AS#4 Assessment Notes – Response to OMR#2 – Protected Matters

Deliberative / contemporaneous notes made during assessment of AS#4 for Protected Matters assessment scope, December 2025 – January 2026.

Key findings for discussion with team – Findings meeting, 20/01/2026

Figure 11: Representation of the selected source locations (orange) over the survey area

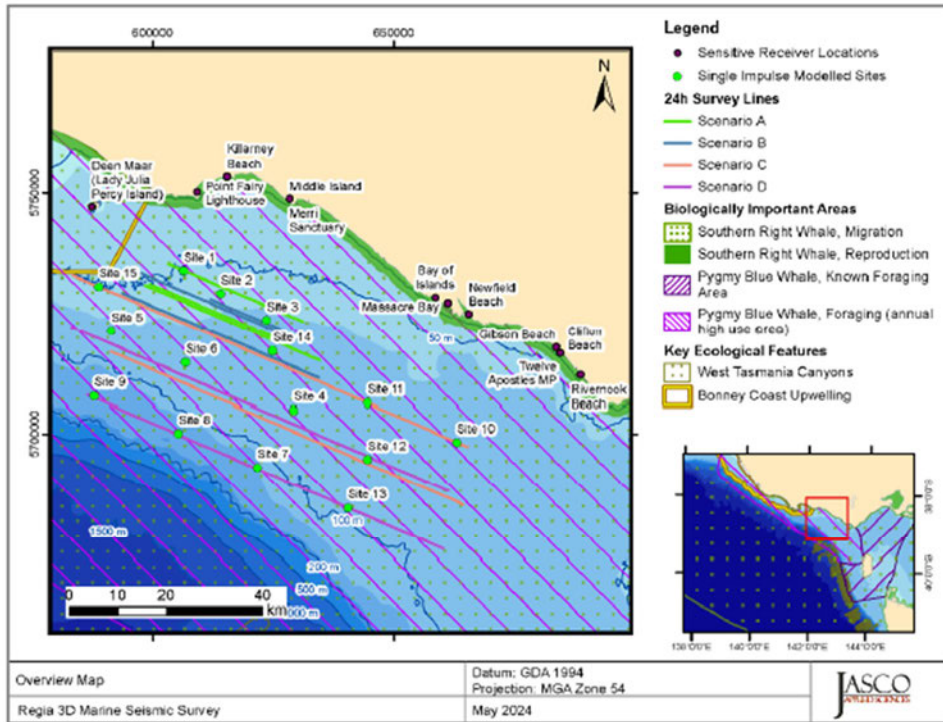
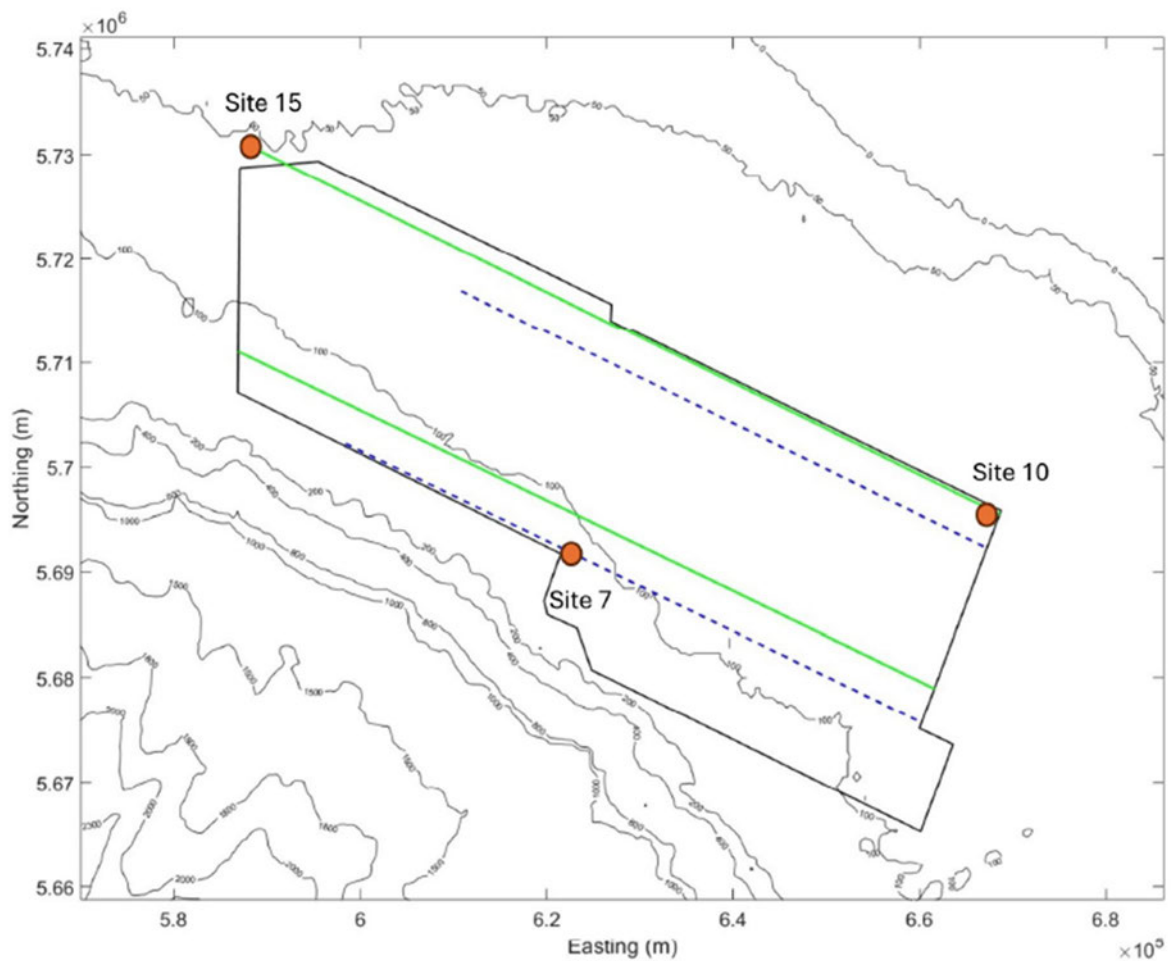
- SLR (2025) scenarios have fewer total impulses in the 24hr assessment period than JASCO (2024) e.g. 11,895 pulses vs 13,508 pulses. Survey area and lines appear to be the same when overlaid. 12.5 SPI is the same. No explanation in EP of why number of impulses has reduced and if this is appropriate. Potentially a longer line turn duration or change in vessel speed (?), noting vessel speed range changed in activity description (Appendix A2).

- Small reduction in source volume (noting comparable source levels) expected to result in negligible change to predicted effect ranges
- Change in SEL24h scenario and shot points could result in small change to predicted effect ranges, but SPI and adjacent lines are the same and would influence these results

- **Section 3.1.2.4 – Behavioural Disturbance Within and Adjacent to the SRW**

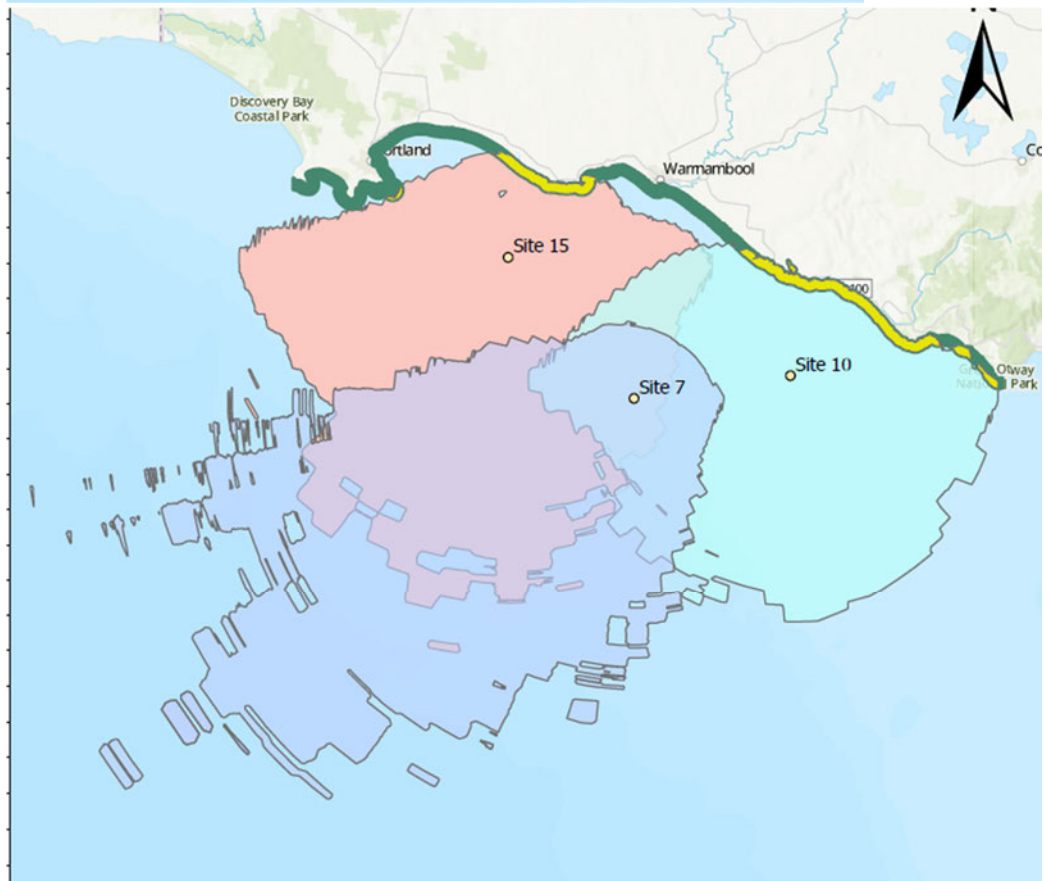
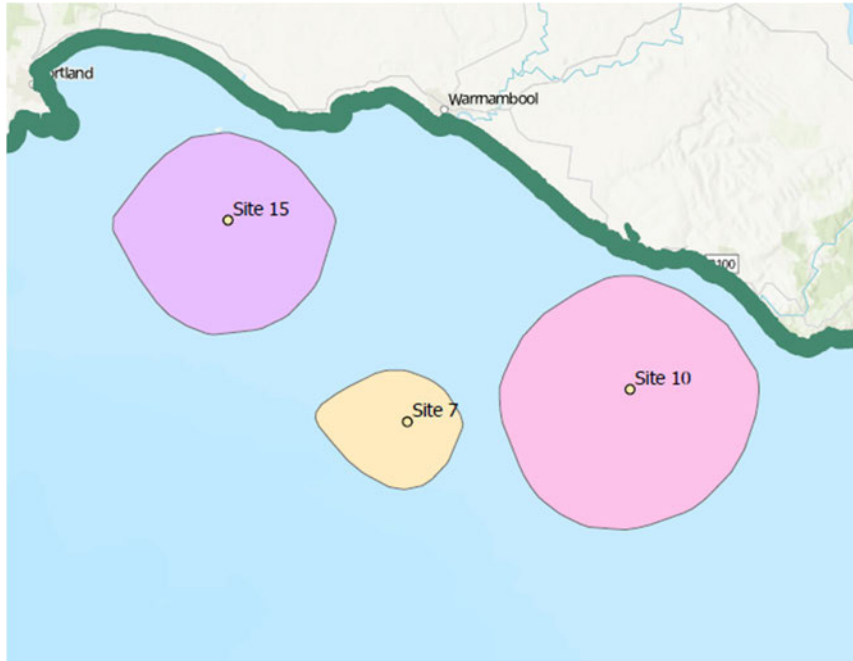
- Engages with the relevant recovery actions
 - Acknowledge that behavioural responses can still occur at levels less than 140 dB, but low severity.
 - Ambient 90 -158 dB, with mean of ~110 dB – Distinguish between natural variability and activity.

- EPO – **No behavioural disturbance will occur to any SRW within the reproduction BIA as a result of the Regia MSS.**
 - Characterise the ambient baseline sound levels in the reproduction BIA recognising variation
 - SSV as close as possible to Reproduction BIA – activity sound does not elevate above defined ambient ranges during sampling periods.
 - Real-time decision making.
